PLAN COMMISSION STAFF REPORT

Agenda Item: PC Docket No. 23-010

Application: **Zoning Amendment – Planned Unit Development Amendment**

Summary: Maple Leaf Crossing LLC requesting approval of an amendment to the Maple Leaf Crossing Planned Unit Development to add parking spaces and modify Lots 2-7 and Outlots A and B.

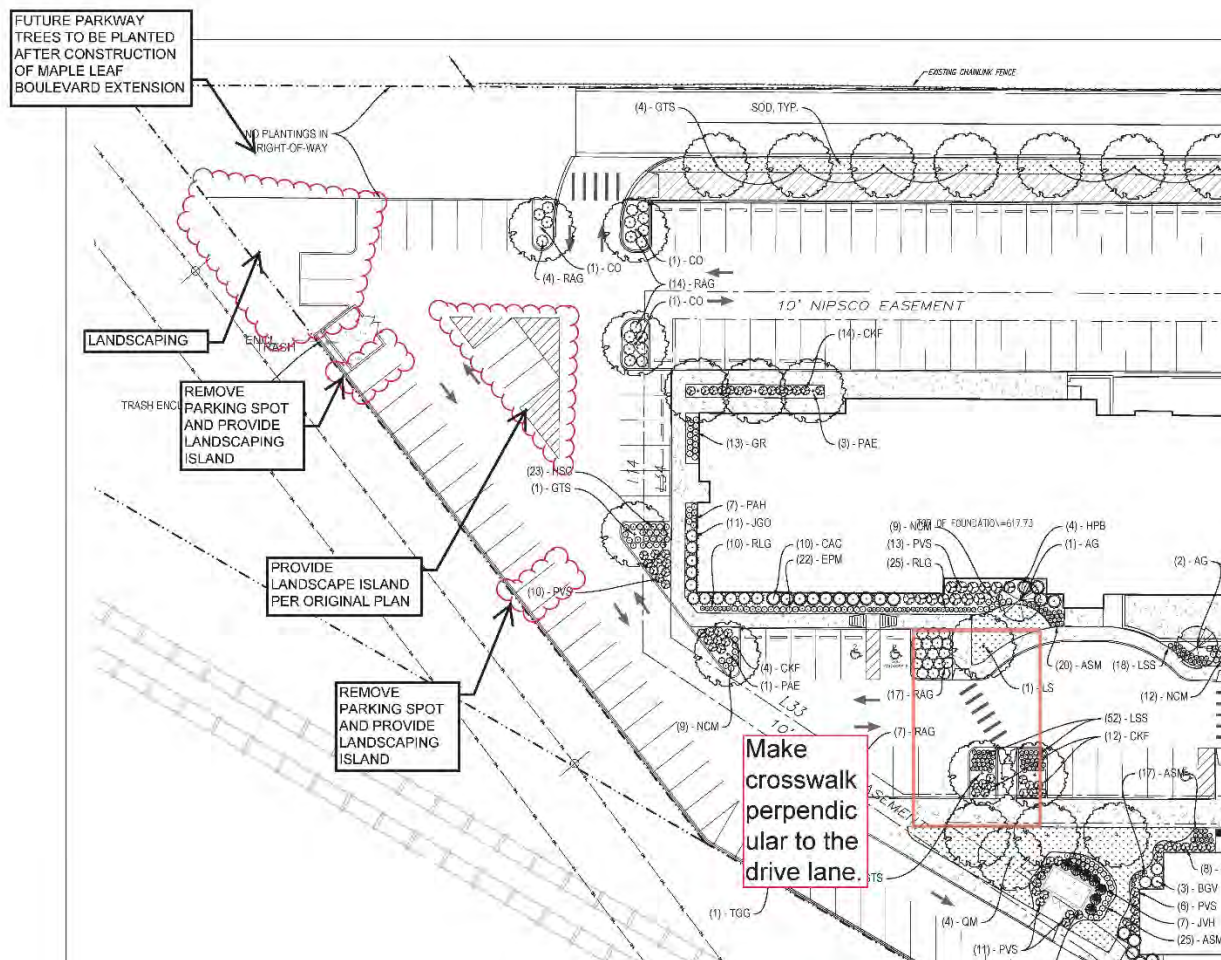
5) Rows of parking fronting on drive aisles including alleys shall be provided with a minimum five feet (5') (excluding curbs) landscaped buffer.

7) For every 2,000 square feet of Parking Area or Parking Lot, at least one Tree shall be installed or preserved within the Parking Area or Parking Lot except to the extent that Trees outside of the Lot containing the Parking Area or Parking Lot are allowed to satisfy this requirement as set forth below.

With these standards in mind, staff has proposed the following modifications to the landscape plan in order to be closer to compliance with the Zoning Ordinance:

- A commitment to plant future parkway trees after construction of the Maple Leaf Boulevard Extension in the right-of-way labeled "No Plantings in Right-of-Way."
- The removal of 3 proposed parking spaces to be replaced with landscaping in the far northwest corner of the site.
- The removal of 1 parking space southeast of the trash enclosure to be replaced with a landscape island in the northwest corner of the site.
- The removal of 3 parking spaces just west of the NIPSCO easement in the northwest corner of the site to be replaced with a landscape island per approved development plan (see Section 26-6.405.O.1.h.vii.I.5).
- The removal of 1 parking space west of the NIPSCO easement in the northwest corner of the site to be replaced with a landscape island (see Section 26-6.405.O.1.h.vii.I.1).

SHEET
C-2.0

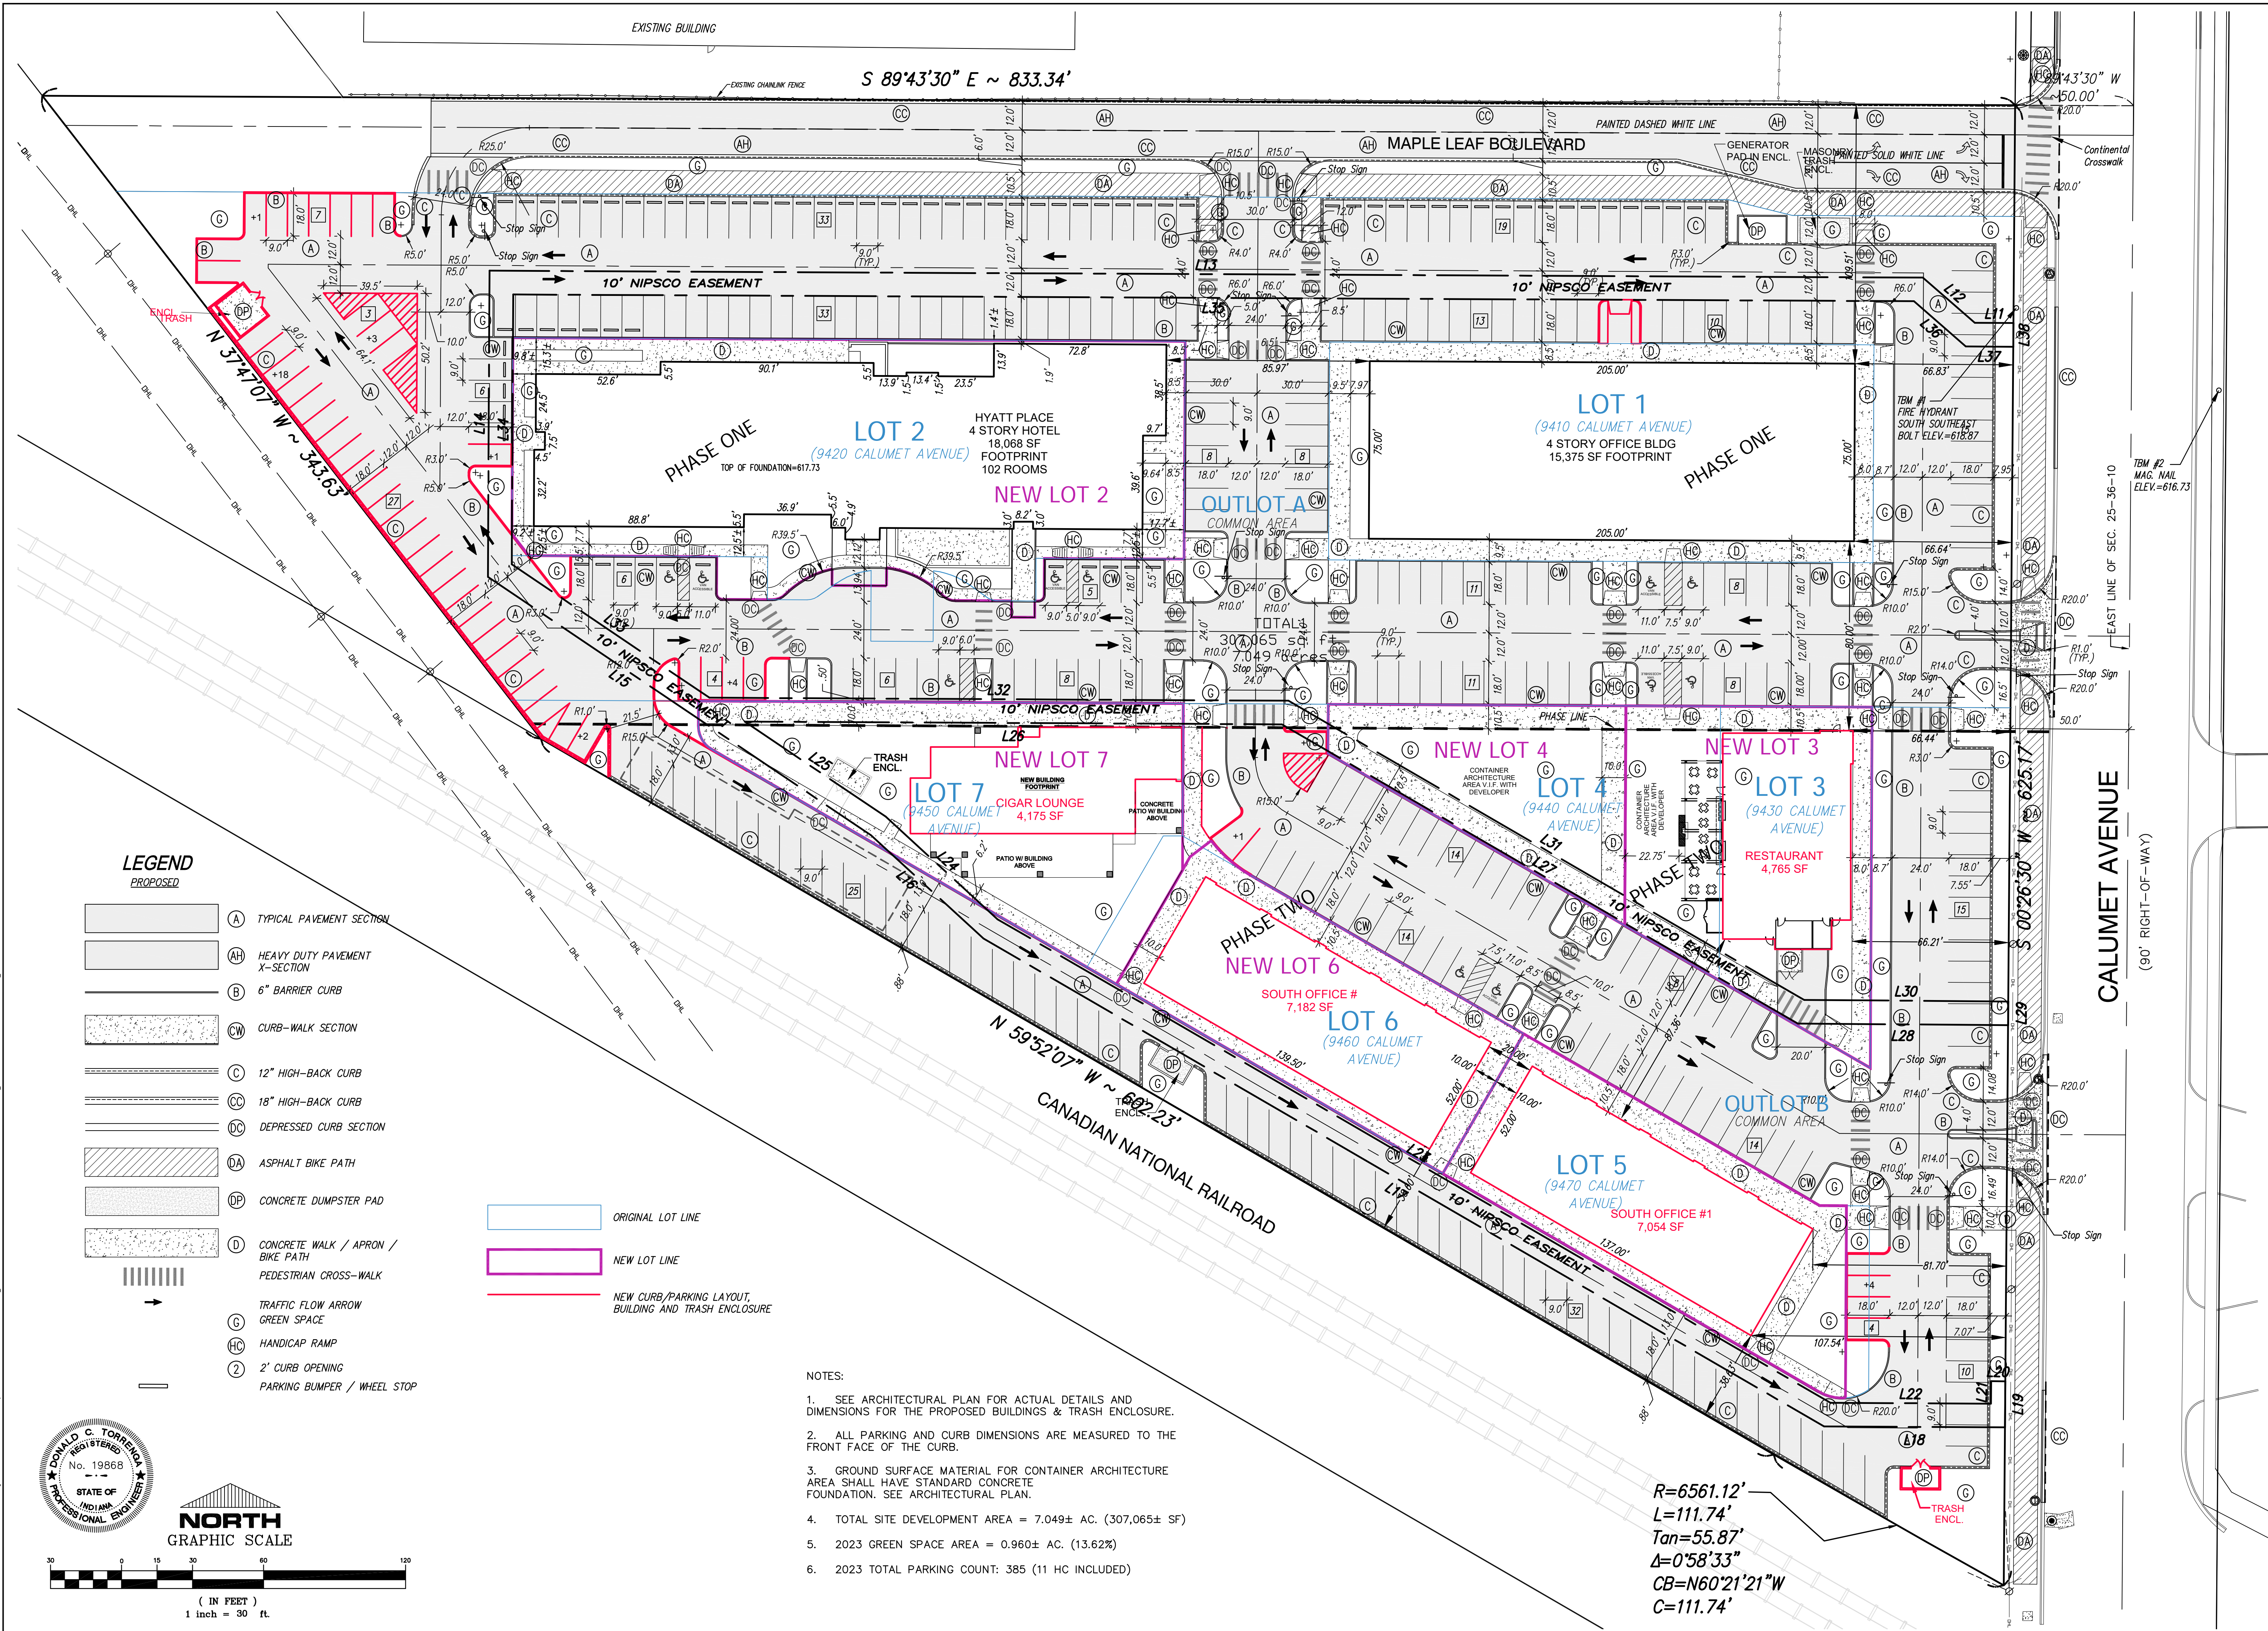
Code/Ordinance	Section	Standard	Proposed	Meets Code
Ord. 1803	6.	Off-Street Parking Facilities Off-street parking shall include approximately 358 parking spaces as set forth in the Approved Development Plan.	Requested number of parking spaces has increased to 385.	Needs Plan Commission Determination*

8.	Pedestrian and Bicycle Access Sidewalks and bicycle paths shall be located within and upon Maple Leaf Crossing as set forth in the Approved Development Plan	The bicycle path through the Maple Leaf Crossing PUD has been removed. A bicycle path remains in the Maple Leaf Boulevard right-of-way.	Needs Plan Commission Determination

However, staff is concerned with the increase in hardscape and the decrease in landscaped areas in the petitioner's proposed plans. Since the petitioner has not provided new evidence or data that additional parking spaces are needed for the approved uses at Maple Leaf Crossing, the need to replace landscaping with parking spaces is not clear. According to the Munster Zoning Ordinance, landscaping for parking lots should follow Section 26-6.405.O.1.h.vii.l. Key parts of this section of the code include the following:

With these modifications, the proposed parking of the site would be decreased by eight (8) spaces, for a total of 377 parking spaces, which is still a 7.1% increase in parking from the approved development plan per Ordinance 1879. See image on next page for more details.

Staff recommends that on the Development Plan, the square footage of the structure proposed for Lot 7 to be updated to reflect the total square footage of the structure (6,400 square feet), rather than the square footage of the first floor of the structure (4,175 square feet). The square footage of the other structures on the site are labeled by total square footage of the structure, so this change will ensure the information displayed on the plan is consistent between structures.

- *A commitment to plant future parkway trees per Munster Zoning Ordinance after construction of the Maple Leaf Boulevard Extension in the right-of-way labeled “No Plantings in Right-of-Way.”*

- *Modifications to the parking areas on the Development Plan that reflect no more than 377 parking spaces in Outlots A and B. These modifications include the following:*

- o *The removal of 1 parking space west of the NIPSCO easement in the northwest corner of the site to be replaced with a landscape island.*
- *A modification to the Development Plan to show the crosswalk in Outlot A between Lot 2 and Lot 7 to be redesigned to be perpendicular to the drive lane.*

- *A modification to the Development Plan to show the square footage of Lot 7 to be updated to the total square footage of the structure (6,400 SF) to be consistent with the square footage labeling of other structures on the Development Plan.*
